AMENDMENTS TO THE DRAWINGS

REMARKS

FIG. 4

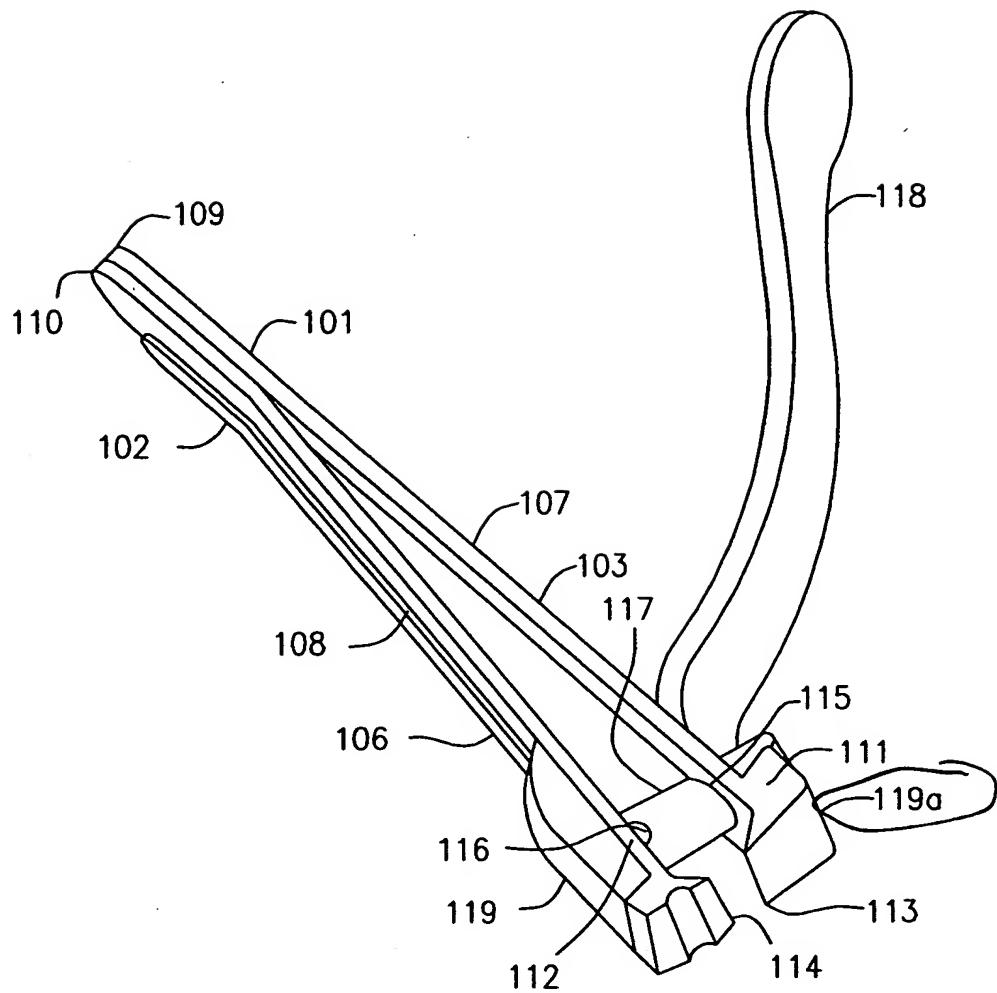
A Figure 4 revised (also corrected to show 119a) as requested by the Examiner is submitted herewith.

The rejection of claims 1, 5-8 and 16-20 under 35 U.S.C. 112, second paragraph, is respectfully traversed. Based on the text of the Office Action, it would appear that this rejection is based on the bumpers being "triangle shaped" but none of the claims have such a requirement. It is respectfully pointed out that Figures 4 and 5 clearly show each embodiment has a bumper 119.

FIG. 5

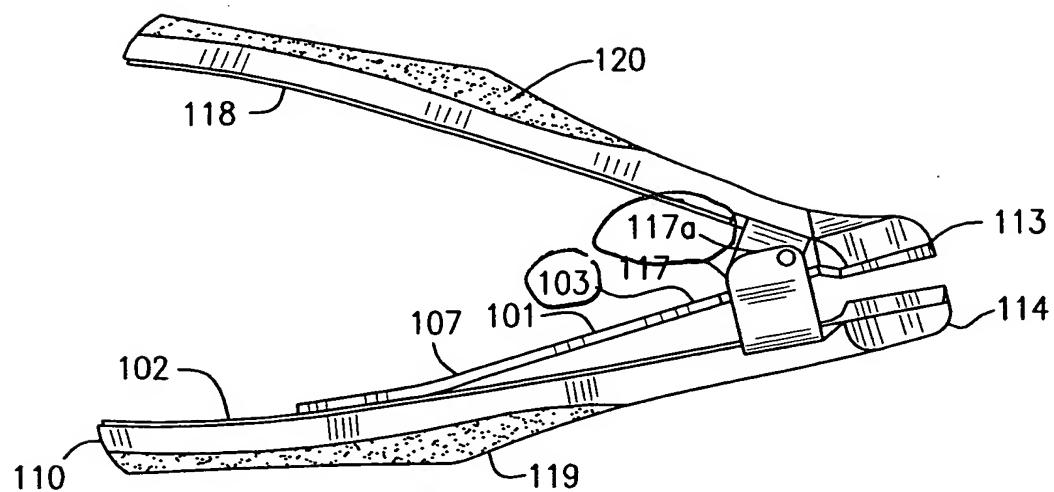
As the Examiner has apparently recognized, Figure 5 is a side view rather than a perspective view. The specification has therefore been corrected. Also, corrected drawings are being submitted for entry after approval of the Examiner. As a result, it is respectfully submitted that the objection to the drawings, objection under rule 1.71 and rejection under 35 USC §112, first paragraph, can now be withdrawn.

Figure 5 shows top member 101, bottom member 102 and post 117. A corrected figure is submitted herewith on which designations the top surface 103 of top member 101, and the top (117a) of the post 117 have been added. It can readily be seen that the top of the post 117a is above the top surface 103 of top member. Since this is a side view and Figure 6 is a top view, it is apparent that cutting edges are at an angle to the central longitudinal axis, and how the members and post interact is apparent. While it is also apparent that the other side can have a similar post, claim 18 has been cancelled in order to moot the issue as to a second post.
